AGENDA FOR THE CANTERBURY BANKSTOWN LOCAL PLANNING PANEL MEETING

| ITEM 1 | 754-774 Canterbury Road, Belmore |
| FILE | DA-255/2018 |

DA-255/2018 ASSESSMENT REPORT

Figure 7 | Concept building layout of Basement for 1A Trafalgar Street.

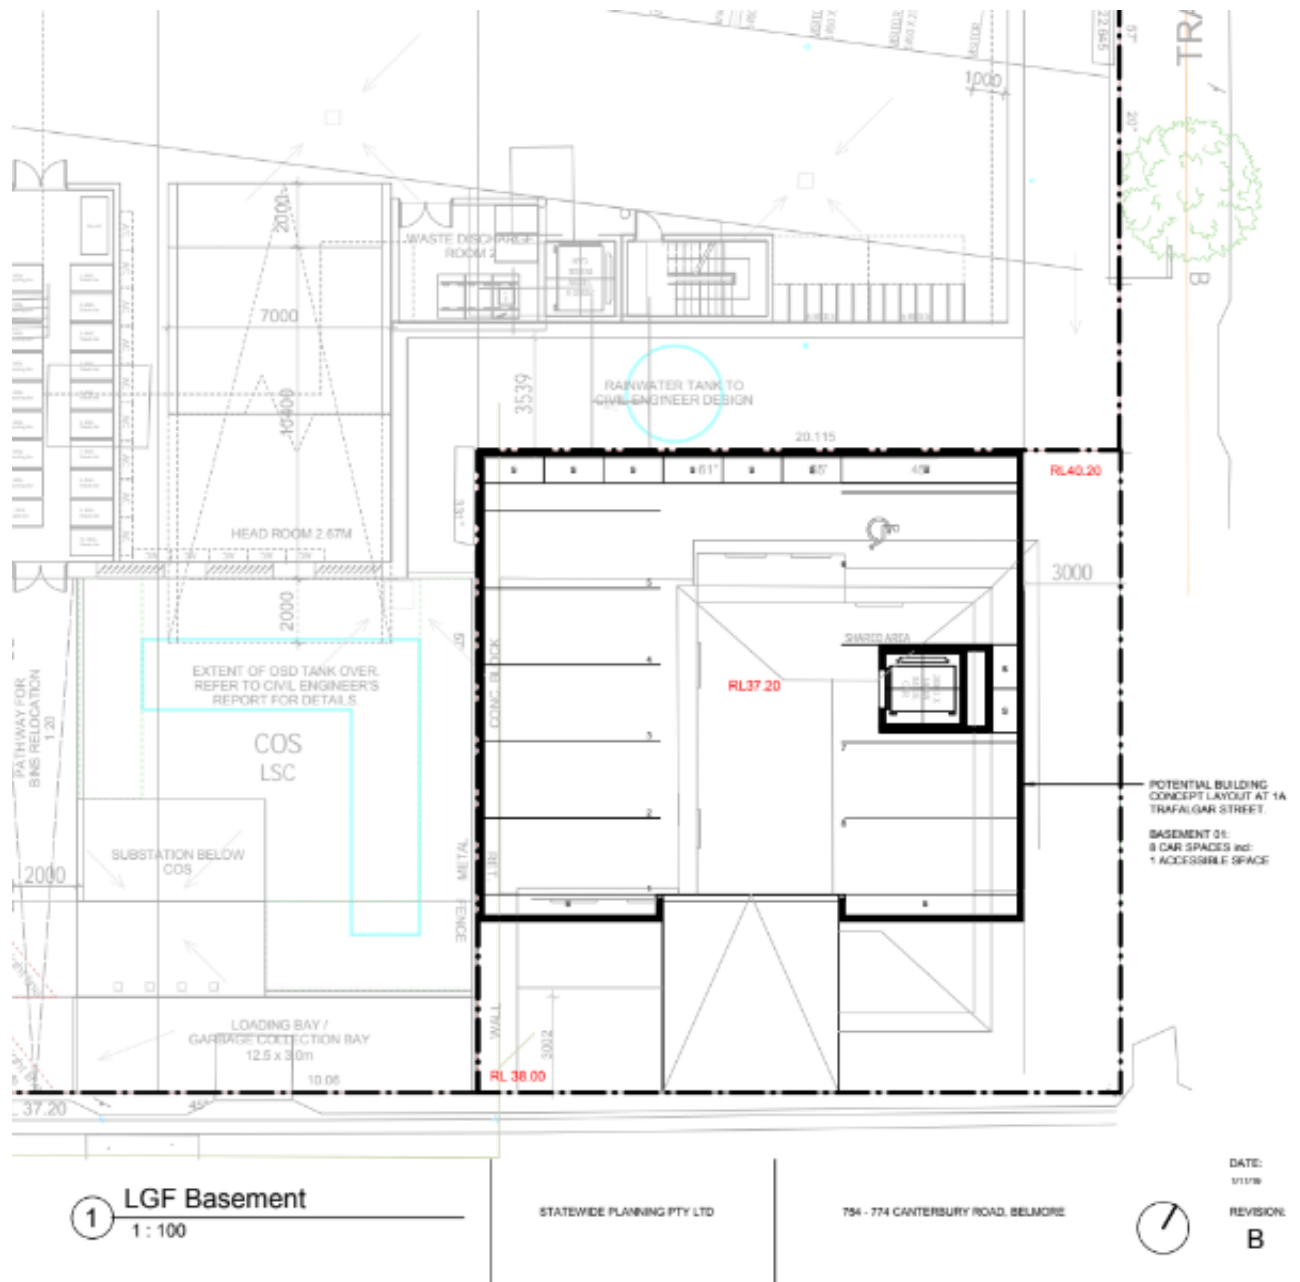
Based on the plans provided above, the applicant has sought to demonstrate that the 'reasonable potential redevelopment' of No 1A Trafalgar Street would be for a 'residential flat building'.

With specific reference to (a) above, the plans supplied provide for a 'potential building envelope' reflecting a development with a 5 storey-built form. The 'potential envelope' identifies the footprint of the development as providing for a 4 metre setback to Trafalgar Street and a 6 metre setback to Chapel Lane while zero setbacks are identified to the sites northern and western boundaries being those boundaries it shares with the subject development site.

The plans also identify a lower car parking level which would accommodate eight car parking spaces with the above 4 residential levels each containing 2 apartments.

With specific reference to (b) above, the scheme would fail to comply with the ‘current applicable planning controls’ as follows:

- Clause C4.2.1.1 (C3) – Minimum Lot Sizes and Frontage of CDCP 2012 states that a “minimum primary street frontage width for residential flat buildings 4 storeys or greater is 30 metres”. The site has a frontage of 20.1 metres to both Chapel Lane and Trafalgar Street. The indicative plans illustrate a 5-storey building envelope. The development would therefore fail the above control.
- Clause B1.3.1 – General Parking Rates from Chapter B1 of the CDCP 2012 requires parking as detailed in the table below:

In light of the above, it is considered that the applicant has failed to demonstrate that the 'building envelope' and 'general layout' of the indicative scheme would comply with the current applicable planning controls as required by C4.
